Revisions to Electric Reliability Organization Definition of Bulk Electric System and Rules of Procedure; Final Rule

[Docket Nos. RM12-6-000 and RM12-7-000; Order No. 773]

Revisions to Electric Reliability Organization Definition of Bulk Electric System and Rules of Procedure

ACTION: Final rule.

Figure 1
Two Radial Systems Eligible for Exclusion E1

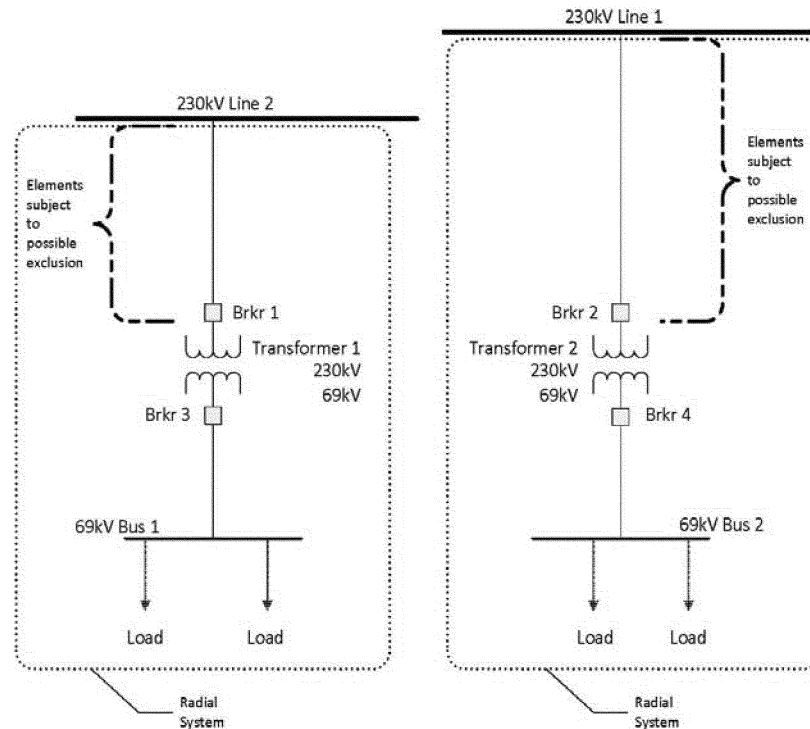
135. NERC and other commenters state that both radial systems depicted in figure 1 would be subject to exclusion E1(a) because they each only serve load.¹²⁶ ELCON agrees with NERC adding that these types of radial systems pose no reliability risk to the interconnected transmission network if the system is lost due to a fault condition. Similarly, SoCal Edison states that the figure 1 facilities would either be excluded or not part of the bulk electric system. SoCal Edison asserts that, because transformers 1 and 2 each have secondary voltages that are less than 100 kV, they do not meet the inclusion I1 requirements and, thus, are not included in the bulk electric system. In other words, SoCal Edison believes exclusion E1 should exclude all radial facilities that are greater than 100 kV up to the point where “the system is no longer radial, as indicated in figure 1 by the brackets where the 230 kV lines meet [lines 1 and 2].”¹²⁷ APPA believes that all the scenarios described by the Commission could create reliability concerns “if taken in isolation and operated in a certain matter” and

136. Anaheim agrees that the radials shown in figure 1 should be excluded and requests clarification that the associated bus work and protection system equipment installed on those radial lines are also excluded. Anaheim advocates that the exclusion should also apply to protection system equipment on the excluded facilities that provide backup protection for devices that are part of the bulk electric system, i.e. lines 1 and 2 in figure 1.

140. The Commission agrees with NERC that the radial systems shown in figure 1 meet the definition of “radial system” in exclusion E1. This configuration would result in the 230 kV lines between transformers 1 and 2 to the two 230 kV lines, respectfully, being excluded from the bulk electric system. The Commission agrees with NERC and other commenters that both radial systems depicted in figure 1 would be subject to exclusion E1 condition (a) because they each only serve load.

Figure 2
Networked Configuration w/115 kV Loop

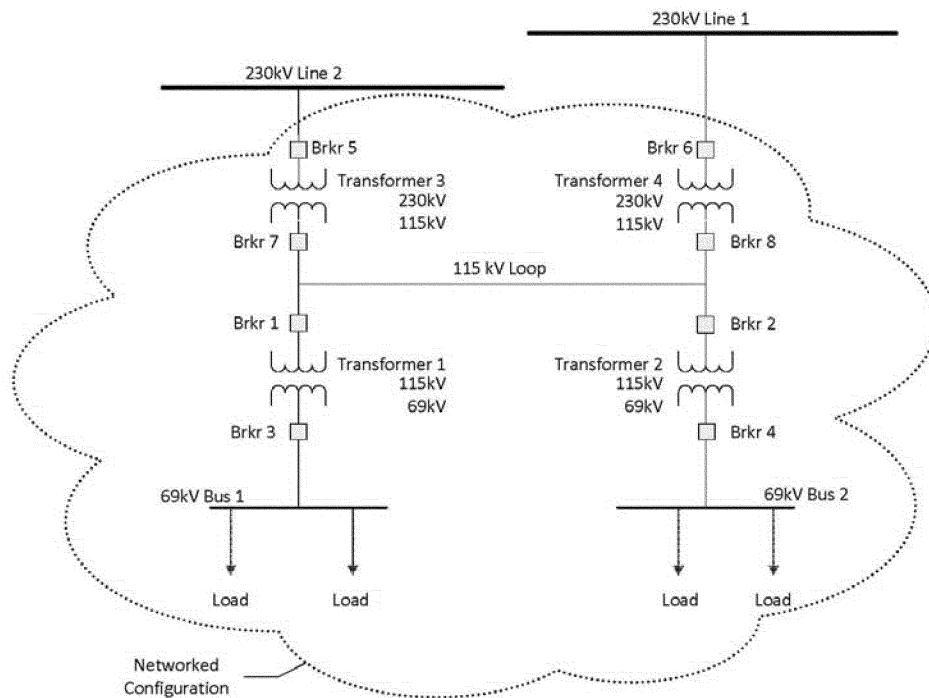
145. NERC states that figure 2 is a non-radial loop on the 115 kV system. According to NERC, the 115 kV elements above transformers 1 and 2 to the point of interconnection with lines 1 and 2 would not be eligible for exclusion E1 because they do not emanate from a single point of connection. NERC also states that it would be appropriate to evaluate figure 2 under exclusion E3 as a potential local network.¹³¹ For such a candidate local network to qualify for exclusion, NERC states that additional technical analysis is needed to determine if all the exclusion E3 criteria are satisfied.¹³² NERC asserts that without such a technical analysis, the 115 kV elements above transformers 1 and 2 should be considered part of the bulk electric system.

146. Likewise, Idaho Power, ITC Companies, and National Grid contend that the figure 2 configuration should be included in the bulk electric system. Southern Companies believe exclusion E1 may apply from the breakers down and that the configuration may belong to

exclusion E3. AEP assumes that each of the facilities below the 115 kV loop shown in figure 2, and including breaker 1 and breaker 2, are radial and excluded pursuant to exclusion E1. According to AEP, the facilities above breakers 1 and 2 may be excluded pursuant to exclusion E3 depending on the circumstances.¹³³

147. Valero states that the figure 2 configuration is very similar to common facilities configurations employed in many industrial facilities involving the interconnection of the industrial facility to the utility through two high voltage feeder lines that originate at different utility owned and operated substations. Valero requests that the Commission include in the final rule an additional exclusion that would “categorically exclude from the [bulk electric system] any on-site high voltage switchyard facilities (less than 300 kV) owned by the industrial end-user where the predominant function of the facilities is to distribute electricity in an inward direction to the end-user’s load.”¹³⁴ WPPC argues that figure 2 shows both radial and network systems and that the system from the 115 kV loop upwards would be assessed under exclusion E3

148. The Commission affirms NERC’s statement that figure 2 is a non-radial loop and thus would not be eligible for exclusion E1 because it does not emanate from a single point of connection. The Commission agrees with commenters that the elements below the 115 kV loop should be assessed as two separate radial systems pursuant to exclusion E1. The remaining elements (the 115 kV loop, transformers 3 and 4 and the 230 kV tie lines above the transformers to the two 230 lines 1 and 2) should be assessed pursuant to exclusion E3 and if the configuration meets the criteria of exclusion E3, the elements could be excluded.

Figure 3
Networked Configuration w/69 kV Loop

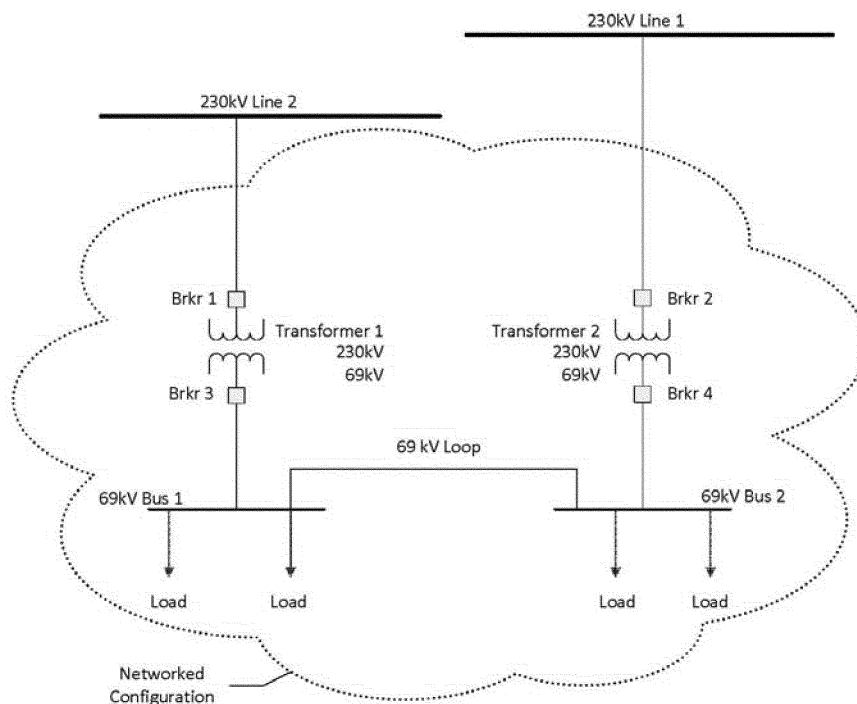
151. NERC disagrees with the Commission's characterization of figure 3 in the NOPR. NERC states that figure 3 does not depict a configuration with two points of 100 kV or higher or a system emanating from two points of connection at 230 kV. According to NERC, except for lines 1 and 2, all the other elements depicted in figure 3 are excluded from the bulk electric system. NERC explains that the elements between line 1 and transformer 2 and from line 2 to transformer 1 are excluded by exclusion E1(a) because "each separate set of [e]lements [described above] is contiguous and emanate from a single point of connection of 100 kV or higher."¹³⁷

153. Exelon agrees with NERC and explains that it has many connections similar to the one shown in figure 3 and provides a specific example where a 138 kV substation is fed by two radially connected 138 kV lines which in turn are connected through 40 MVA transformers to a 12 kV bus section. Exelon states that in its example the 40 MVA transformers cross bus sections so that if one of the 138 kV lines is out of service, each side of the 12 kV bus retains service. Exelon believes that due to the high impedance of the transformers, little energy flows between the buses in Exelon's

154. Other commenters believe that the figure 3 configuration may not be eligible for exclusion E1. SoCal Edison explains that the 69 kV loop is not open and therefore is a parallel path to the 230 kV system. BPA, Alameda and WREA do not view the figure 3 system as eligible for exclusion E1 because the system is networked. Idaho Power states that the 230 kV lines would be included only if there is a protection system in place for the 230 kV lines. According to Idaho Power, the elements above the transformers in figure 3 would not be excluded from the bulk electric system. Idaho Power believes this configuration should be evaluated under exclusion E3.

155. The Commission finds figure 3, which is identical to figure 5, is a networked configuration through a 69 kV loop and does not qualify for exclusion E1. The Commission also finds that, because the load in figure 3 can be served by either 230 kV line, it does not depict a “radial system.” However, the facilities below 100 kV may or may not be necessary for the operation of the interconnected transmission network, and this decision can be made case-by-case in the exception process. In other words, such facilities below 100 kV depicted in figure 3 would be excluded under the general threshold of the core definition unless found on a case-specific basis as necessary for the reliable operation of the interconnected transmission network. Thus, the Commission, while disagreeing with NERC’s interpretation, does not propose to include the below 100 kV elements in figure 3 in the bulk electric system, unless determined otherwise in the exception process. Further, as we discuss below in connection with exclusion E3 and figure 5, while we find that the configuration shown in figures 3 and 5 would not be eligible for exclusion E1, we believe that such configurations should be eligible for exclusion E3 for local networks. However, exclusion E3 as written requires the candidate local network to be contiguous and above 100 kV, thus, the exclusion E3 language as written does not allow for figures 3 and 5 to be eligible for the local network exclusion

because they are not contiguous *and* include facilities that are not above 100 kV. Therefore, we direct NERC to modify exclusion E3 to remove the 100 kV minimum operating voltage in the local network definition. This modification will enable configurations similar to figures 3 and 5 to be assessed for the local network exclusion. The Commission believes this modification, together with satisfying the criteria outlined in exclusion E3, will appropriately exclude local network configurations that are not necessary to the reliable operation of the interconnected transmission network.¹³⁹

Figure 5
Networked Configuration w/69 kV Loop

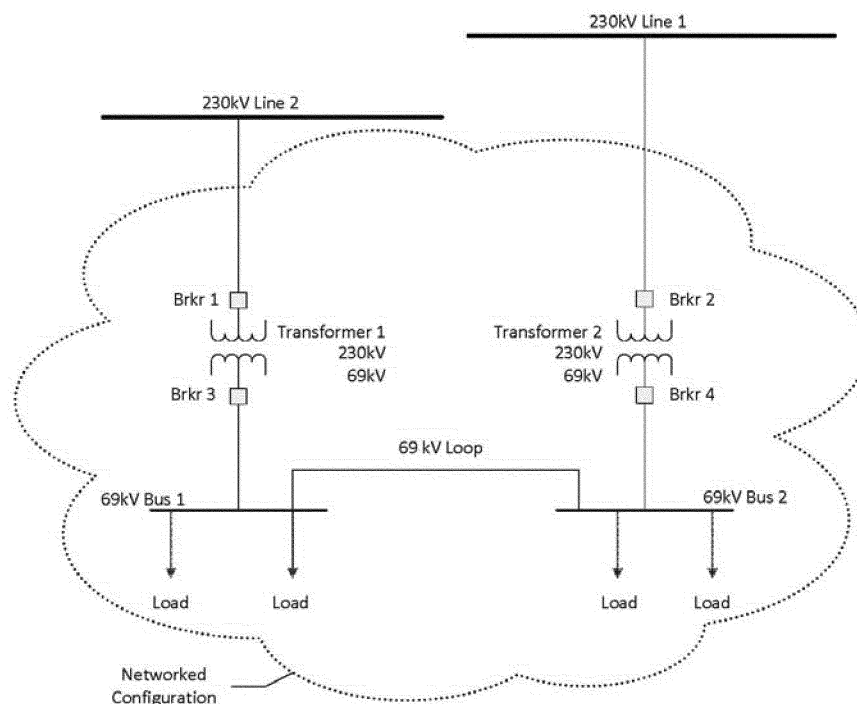
195. In the NOPR, the Commission stated that figure 5 depicts a group of elements that are contiguous through a 69 kV loop and requested comment whether the configuration in figure 5 qualifies as a local network and, in particular, whether the configuration satisfies the conditions that a local network be contiguous and operated at or above 100 kV.

196. NERC views figure 5 the same as figure 3—as a looped system below 100 kV—that is not considered under this exclusion because the elements below 100 kV are presumed to be not part of the bulk electric system.¹⁶⁷ NERC maintains that, if it is determined that the sub-100 kV looped system is necessary for the reliable operation of the interconnected transmission network, the exception process may be utilized to include the appropriate elements. NERC states that figure 5 depicts two separate and distinct groups of elements that each emanate from a

197. Exelon states that the clear intent of the definition is that configurations such as shown in figure 5 are radial systems subject to exclusion E1 (radial systems). According to Exelon, had this not been the intent of exclusion E1, exclusion E3 would have allowed for a local network where the tie was below 100 kV to avoid a reliability gap. Exelon believes that the configuration shown in figure 5, which is identical to figure 3, does not qualify as a local network within the terms of exclusion E3 and supports NERC's view that figure 5 represents two radial systems that qualify under exclusion E1. Exelon cautions that, if the Commission determines that the systems depicted in figure 5 do not qualify under exclusion E1 because of the low voltage tie and does not qualify under exclusion E3 because the tie is at low voltage and not a 100 kV or above, such a decision would leave a gap under which a substantial number of facilities that are not part of the bulk electric system

would be classified as such. Exelon states that it would have to go through the separate exception process for dozens of substations, at great cost and for no useful purpose. Exelon states that the Commission should clarify that the configuration shown in figures 3 and 5 qualifies as a radial system and is excluded pursuant to exclusion E1.

199. As discussed above, the Commission is directing a modification to exclusion E3 to better capture local networks like those depicted in figure 5. The Commission notes that Exelon believes that the configuration shown in figure 5, which is identical to figure 3, does not qualify as a local network within the terms of exclusion E3. While figures 3 and 5 are a networked configuration through a 69 kV loop, they do not qualify for the local network

exclusion because exclusion E3 defines local networks as “[a] group of contiguous transmission Elements operated at or above 100 kV but less than 300 kV that distribute power to Load rather than transfer bulk-power across the interconnected system.” The configuration in figure 5 includes elements that are below 100 kV, and does not have contiguous elements operating at or above 100 kV but less than 300 kV. As noted above, while the Commission finds that these configurations should not be eligible for exclusion E1, we believe that they should be eligible for the local network exclusion. Therefore, we direct NERC to modify exclusion E3 to remove the 100 kV minimum operating voltage in the local network definition. Within 30 days of the effective date of this Final Rule, we direct NERC to submit a schedule outlining how and when it will make the modification to the definition.
